# Access Compliance Report

## Public Rights-of-Way

### (Curb Ramps)

Intersection ID: 9703	Main Street: SHANNONHOUSE_DR	Cross Street: THE_PLAZA	Location: SE
ADA ID: 3101CA73790E	Ramp Type: Perp	Initial Pass/Fail: Fail	Overall Compliance: No
Severity Score: 21.25			
Codes/Mitigation Info/Possible Solution		Field Measurements/Component Compliance

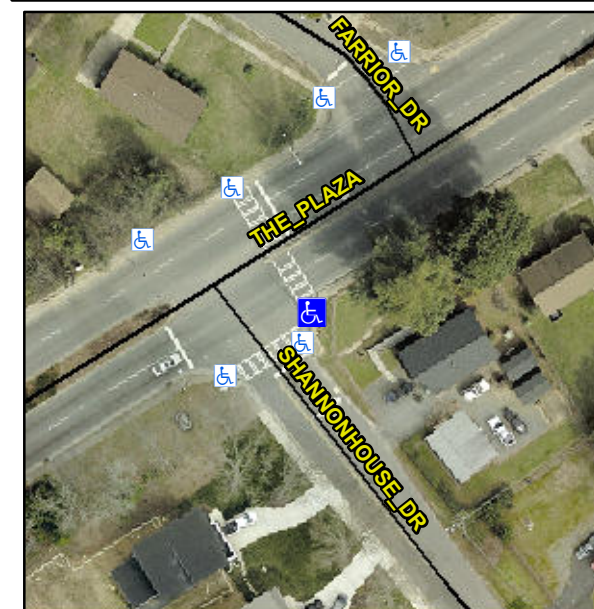
**Not Found, R304.5.1, R304.2.2**

Compliance	Description	Data	Compliance	Description	Data
N/A	Ramp Length (in)	61.0	No	Ramp Slope (%)	11.3
No	Ramp Width (in)	47.5	Yes	Ramp XSlope (%)	1.7
N/A	Flare Type LT	N/A	N/A	Flare Type RT	N/A
N/A	Flare Slope LT (%)	N/A	N/A	Flare Slope RT (%)	N/A
N/A	Flare Traversable LT?	N/A	N/A	Flare Traversable RT?	N/A
N/A	Landing Length (in)	N/A	N/A	DWS Provided?	N/A
N/A	Landing Width (in)	N/A	N/A	DWS Contrast?	N/A
N/A	Landing Slope (%)	N/A	N/A	DWS Length (in)	N/A
N/A	Landing X Slope (%)	N/A	N/A	DWS Full Width?	N/A
N/A	Landing Curb? (Y/N)	N/A	N/A	DWS Offset (in)	N/A
N/A	Shared Landing?	N/A			
N/A	Gutter Ponding?	N/A	N/A	Gutter Slope (%)	N/A
N/A	Gutter Lip Ht (in)	N/A	N/A	Gutter X Slope (%)	N/A
N/A	Painted X Walk1?	Yes	N/A	Painted X Walk2?	N/A
	X Walk 1 Direction	To NW		X Walk 2 Direction	N/A
N/A	X Walk 1 Width (in)	105.5	N/A	X Walk 2 Width (in)	N/A
	X Walk 1 Slope (%)	1.1		X Walk 2 Slope (%)	N/A
	X Walk 1 X Slope (%)	0.4		X Walk 2 X Slope (%)	N/A

**Remove & Replace Entire Ramp.**
